MGPA version 2 submission status – Mark Raymond / Jamie Crooks (RAL)

on-chip current reference

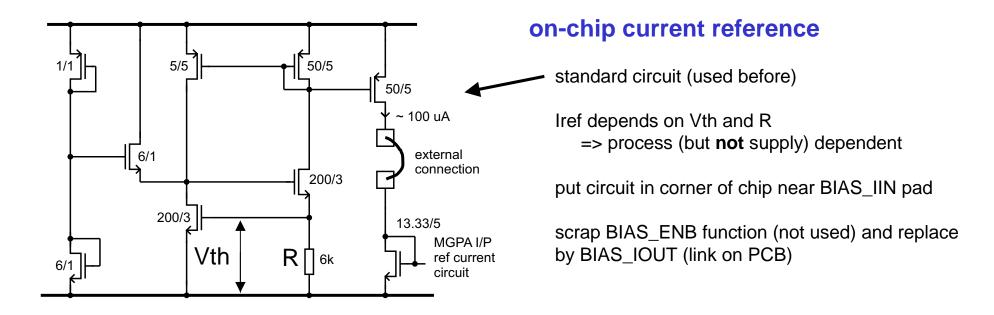
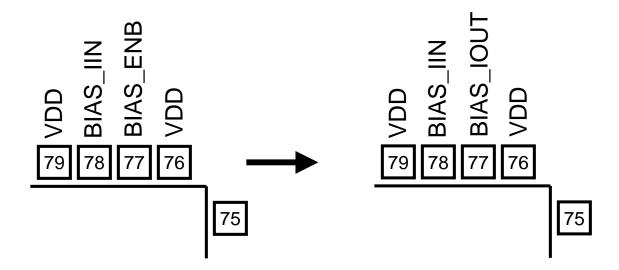
measured pedestal dependence on supply voltage

improves pedestal stability to supply drift

~ 7.5 mV VDD drift -> 1 lsb pedestal drift (if Iref const.)

(factor ~ 6 improvement on resistor to VDD)

=> worth having

re-arrange digital signals

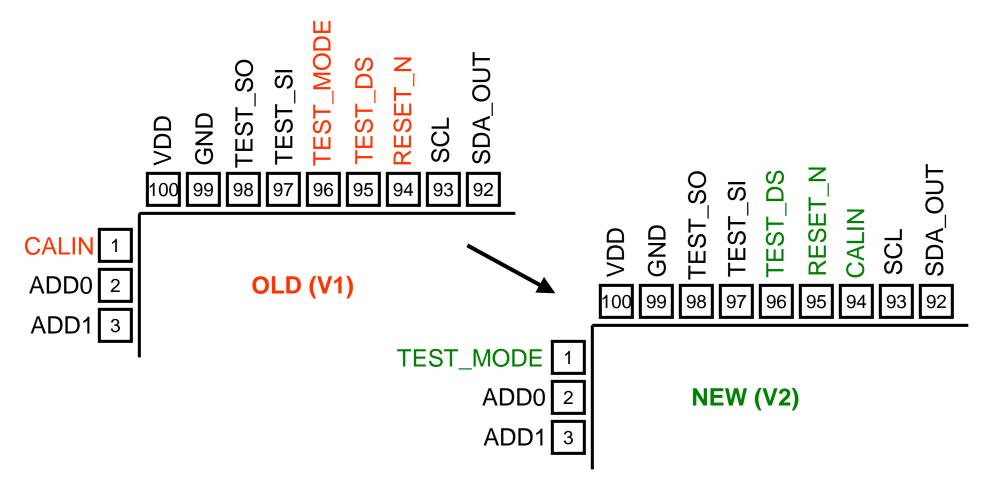
allows CALIN (2.5V transition) to route well away from MGPA I/P on VFE card (1 line for all 5 chips)

=> V1 and V2 pinouts **not** compatible

change I²C default settings

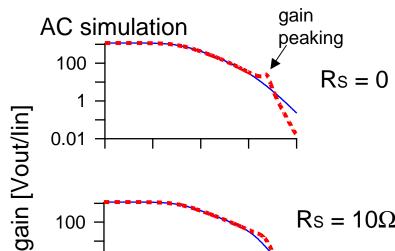
user request for non-zero default settings for pedestals, cal mode ON and non-zero DAC value chip usable (and testable) wthout I²C control

problem: I²C block synthesized -> don't want to re-synthesize and re-route (risk, time)

solution: can make manual changes to wiring but each bit requires several cuts/straps X 3 (triplicated registers)

- => can be done but bigger job if several bits/register
- => limit changes to one bit/register

all 3 pedestal registers default to 64 control register defaults to cal ON DAC defaults to 4 (~ 2/3 fullscale signal on high gain range for Cinj = 10 pF)

1st stage stability – any improvement possible?

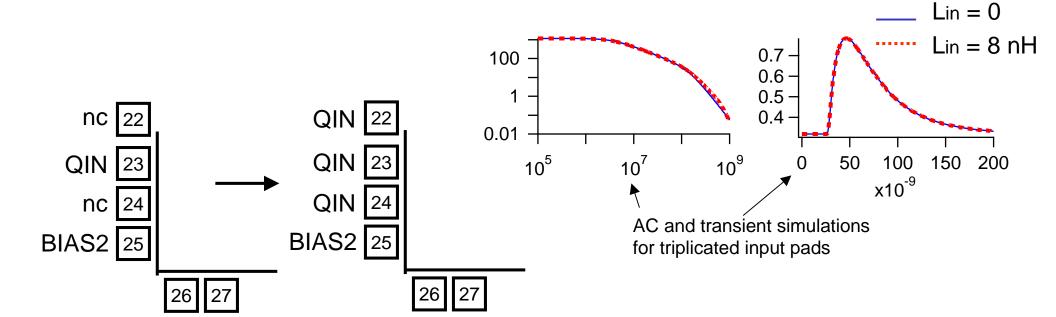
need series resistors to damp effect of parasitic L (bondwire/package)
-> effective fix for current VFE card
observed behaviour can be simulated – gain peaking in AC simulation
-> instability in transient simulation
stable if series resistor inserted

yes – if make use of spare pads either side of current Qin pad can reduce Lin by factor 3

minor change to wiring, no change to 1st stage layout -> improved stability margin -> worth having
